PROJECT: SYMPHONY PARK AT UNION PARK, PARCEL M-3

CITY OF LAS VEGAS INTER-OFFICE MEMORANDUM				DATE: May 9, 2011
TO: **Land Development Services** Department of Public Works				**FROM:** Albert Sung, P.E. Flood Control Project Engineer Department of Public Works
SUBJECT:	Drainage Study for: **Symphony Park at Union Park, Parcels M-1, M-2 & M-3**			**COPIES TO:** Martin & Martin Civil Engineers
Cross Streets:	Symphony Park Ave. & Promenade Place			City Parkway V Inc.
File Number:	F:\Depot\DSMemos\DS4527B.doc			Bart Anderson, P.E., DevCo
Parcel Number:	139-34-211-001; 139-33-511-009 & -010			
Zoning Action:	SDR-41033			
FEMA Flood Zone	YES	NO	**X**	
Proposed Storm Drain	YES	NO	**X**

ADDENDUM #1 TO TECHNICAL DRAINAGE STUDY Update for Symphony Park

RE: Addendum I to The Technical Drainage Study
Symphony Park at Union Park, Parcels M1, M2 & M3
DS #4527A
Martin & Martin Project Number: 3119

CANOPY/ENCROACHMENT EXHIBIT

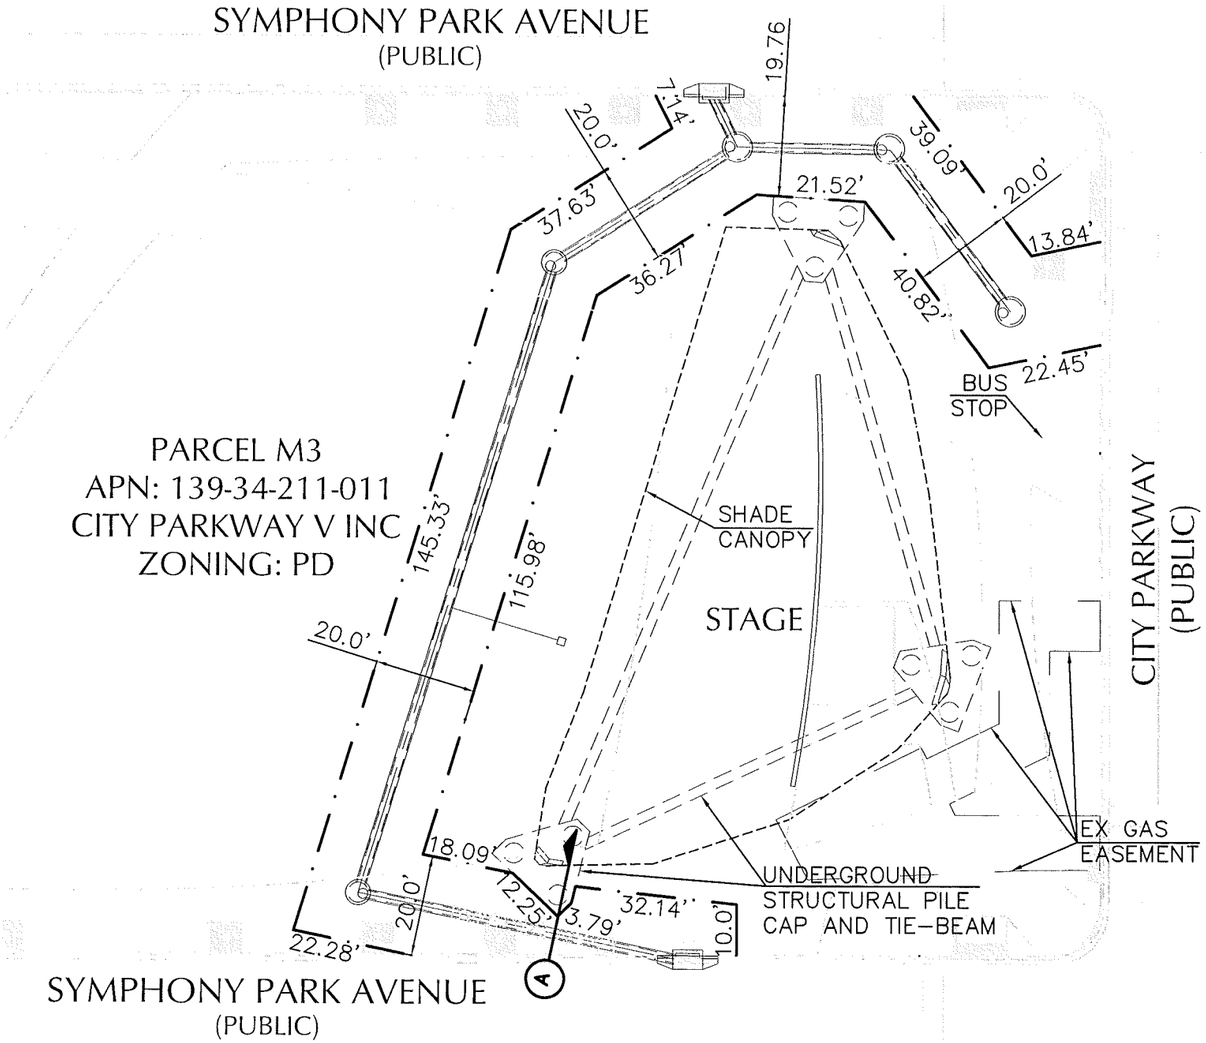
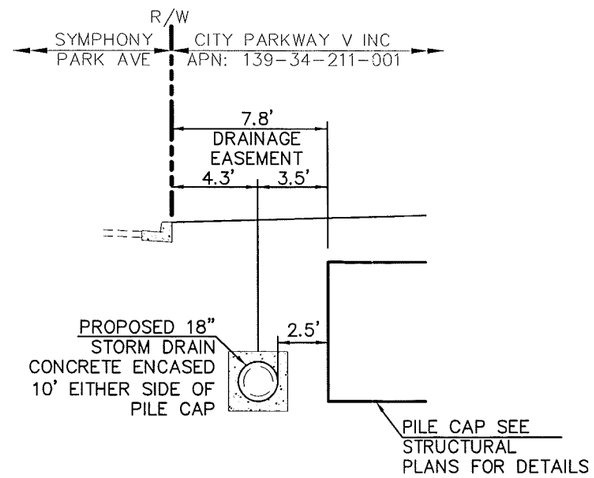
Comment 5 Sheet C4.02: Provide a 20'-wide public drainage easement (privately maintained) centered to the proposed onsite storm drain system. The easement must be granted and recorded by separate document prior to the final acceptance of improvement plans.

Response 5 **A 20' wide public drainage easement (privately maintained) will be provided except for a small section where a pile cap is to be located. Please see cross section J on Sheet C8.01 and Canopy/Encroachment Exhibit.**
